PUBLICATION INDEX

SGS 1-26

K & L SOARING, LLC
5996 STATE ROUTE 224
CAYUTA, NY 14824

FIGURE 1. ELEVATOR PUSHROD (P/N 26B-12 -1A)

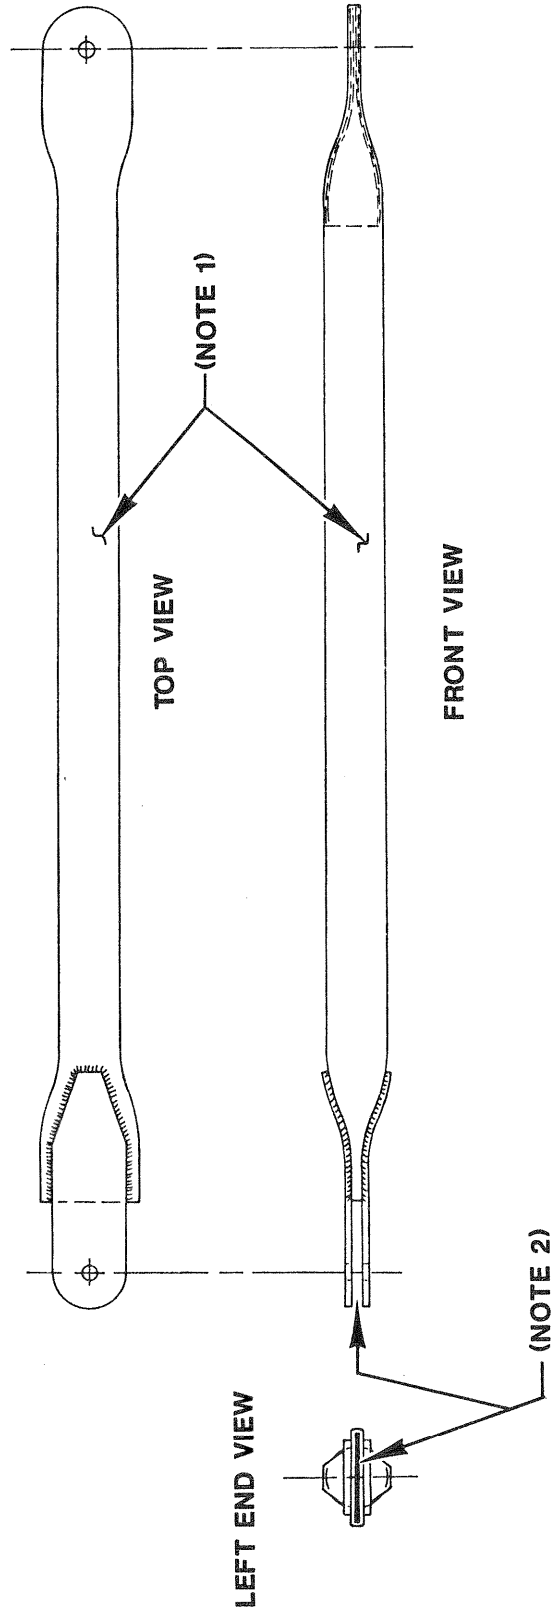
- a. Remove cotter pin, nut, washers, and bolts securing push rod at each end.
- b. Remove push rod.
- c. Inspect exterior of push rod for corrosion. No exterior corrosion is allowed. (Refer to Figure 1.)

- d. If no exterior corrosion is found, use a high intensity light to inspect the push rod interior surface through the open end of the tube. (Refer to Figure 1.) No interior corrosion is allowed.

- e. If any interior or exterior corrosion is found, replace push rod with a serviceable 26147B-1 push rod. If there is any question whether interior or exterior corrosion exists, replace push rod or consult the factory.

- NOTES: 1. INSPECT EXTERIOR OF PUSHROD FOR CORROSION.
NO CORROSION IS ALLOWED.
2. INSPECT INTERIOR SURFACE OF PUSHROD FOR CORROSION BY SHINING
HIGH INTENSITY LIGHT THROUGH OPEN END OF TUBE.
NO INTERIOR CORROSION IS ALLOWED.

SEAT ADJUSTMENT BRACKET

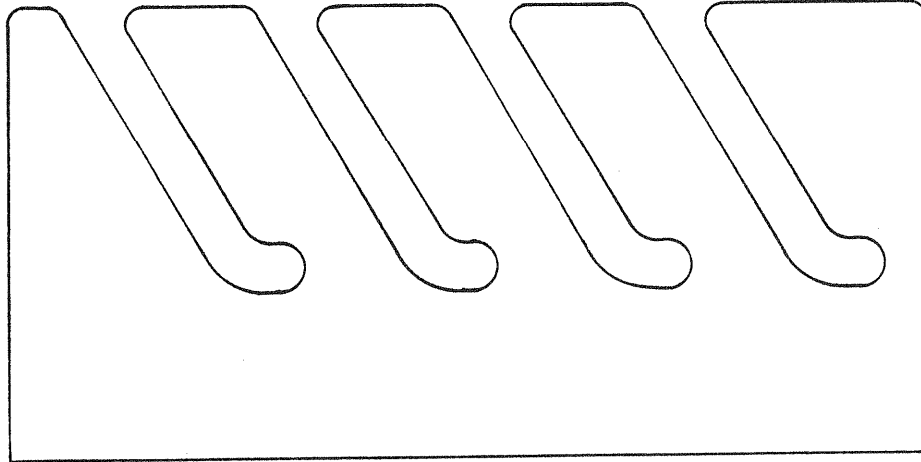
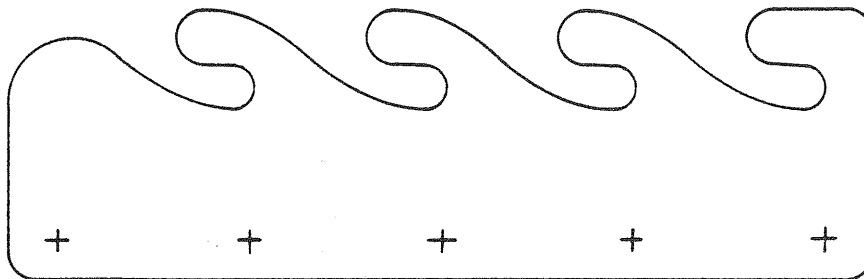
PREFACE: Reports indicate that on the affected aircraft, the pilot's seat back could inadvertently slide back during tow, when experiencing turbulence or during certain flight attitudes where a negative g condition may exist. A new bracket, (PN26245D-3), and spacer, (PN26245D-5), has been designed to resolve this problem. This service bulletin lists instructions to install this improved seat back adjustment bracket. This improved bracket should reduce the possibility of sudden seat back movement.

- a. Drill out rivets securing existing seat adjustment brackets. Remove brackets.
- b. Clean up bracket mount area removing any burrs and sharp edges.
- c. Paint bracket mount areas with a thin coat of Zinc Chromate or equivalent primer to prevent corrosion.
- d. Place the spacer between the inside fuselage wall and the lower edge of bracket.
- e. Mark the mount area and drill holes as per old bracket using a #30 drill bit and secure with Cleco.
- f. Install rivets (MS20426AD4) (5) places on each bracket and spacer kit.
- g. Paint exterior of rivet heads.
- h. Record compliance with this service bulletin in the aircraft log book.

NEW DESIGN 26245D-3 BRACKET
